Japan Comments for Battery Durability GTR EVE37

8.September.2020

5. Information about SAE-OBD-PID

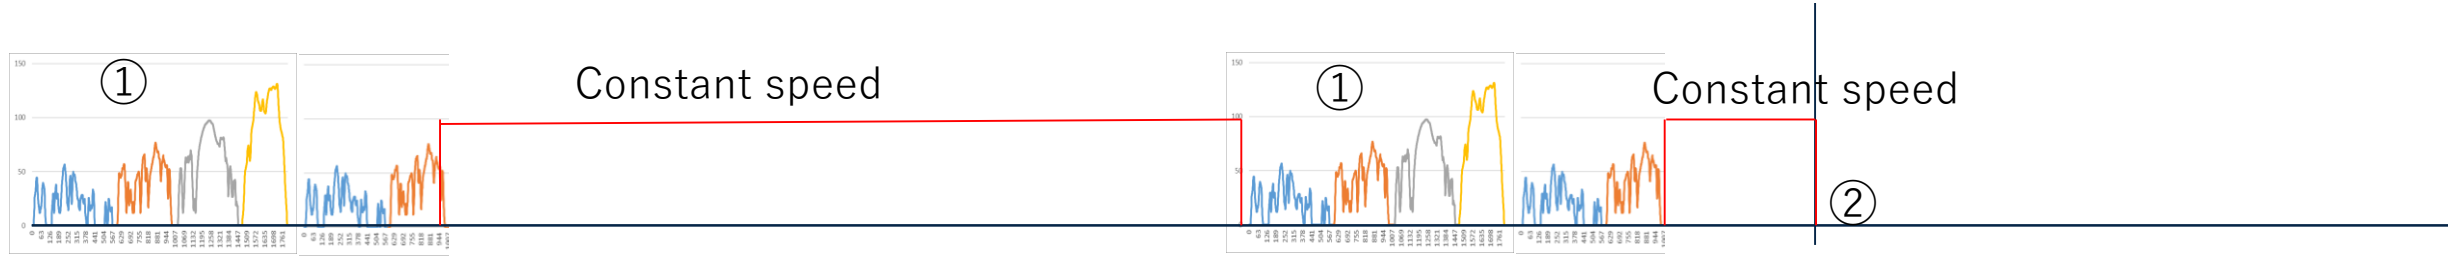
Japan has already applied “ SOH “ for the purpose of our guideline to SAE and PID has been given.

It will be published in October because it will be voted and published together with J 1979 -2 (Response to the CARB OBD revision) which is currently underway.

Main factor for the degradation of electric consumption

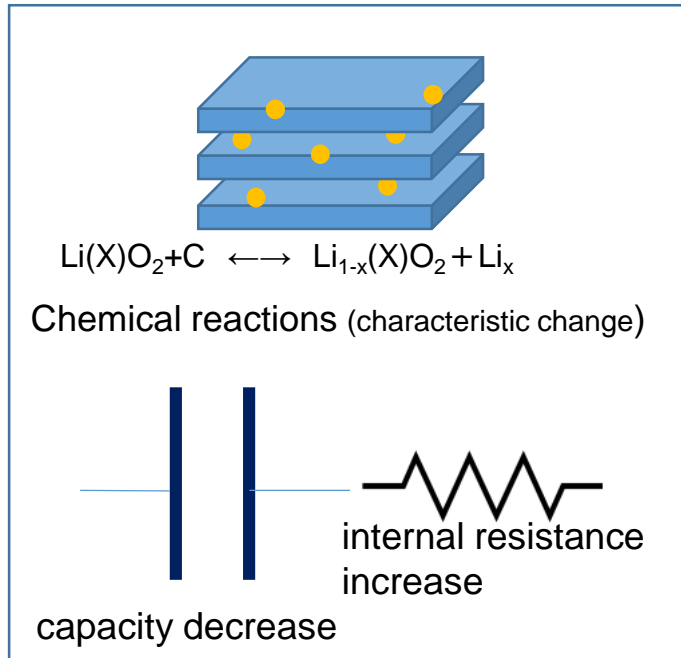
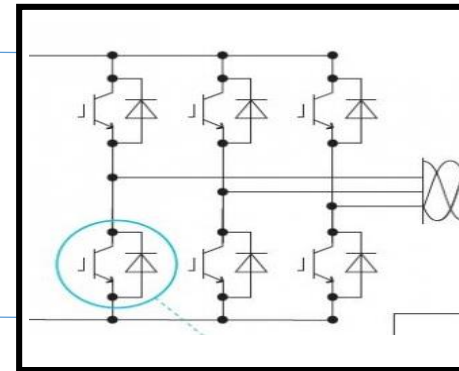
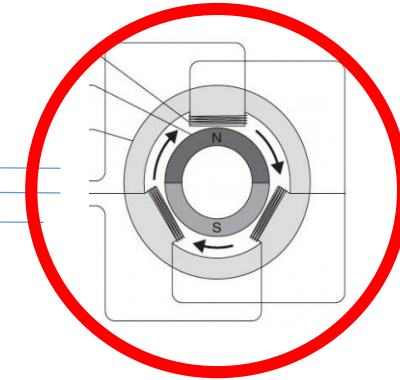
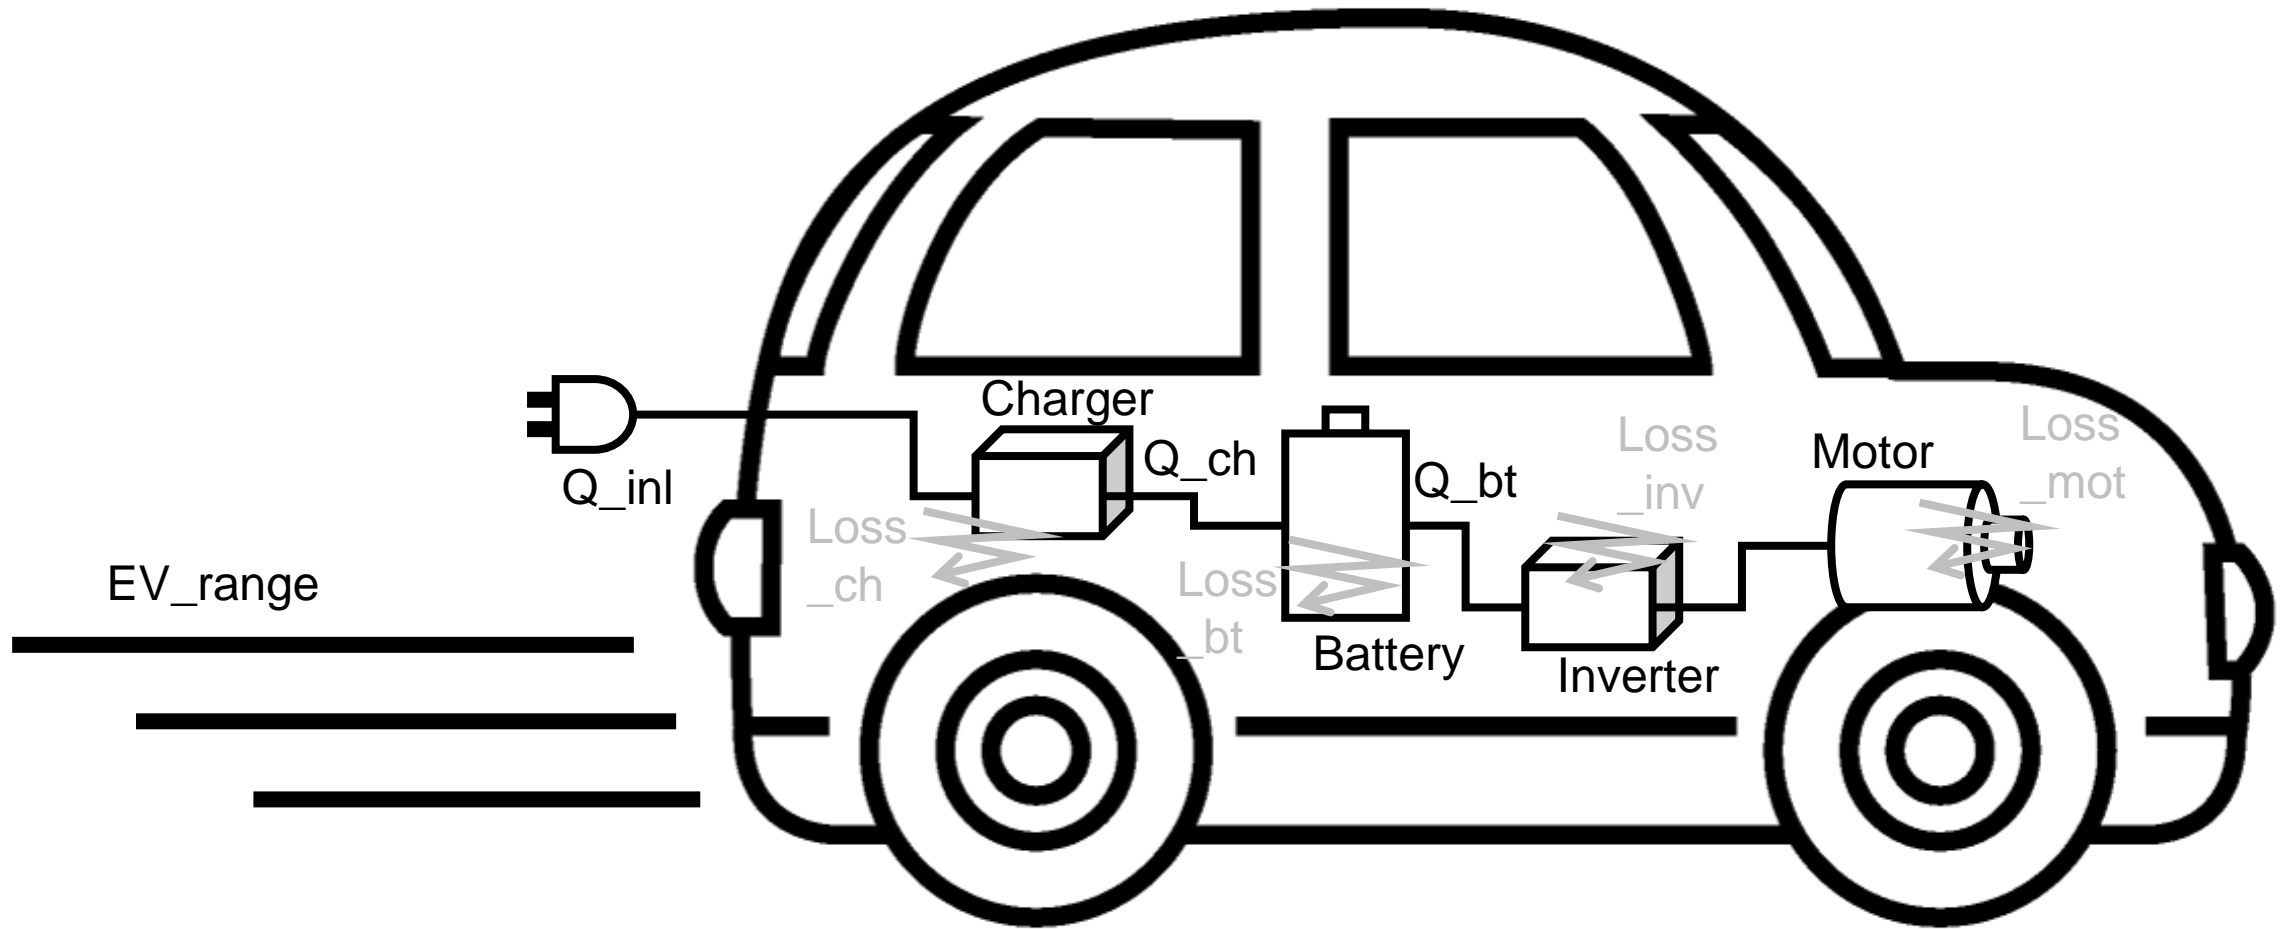
DATA required: Comparison between new and durable components

1. Inverter efficiency (It can be substituted by the single durability result.)
2. Motor performance (It can be substituted for the single unit durability result.)
3. Battery performance

The effect of the increase in internal resistance should be minimal.
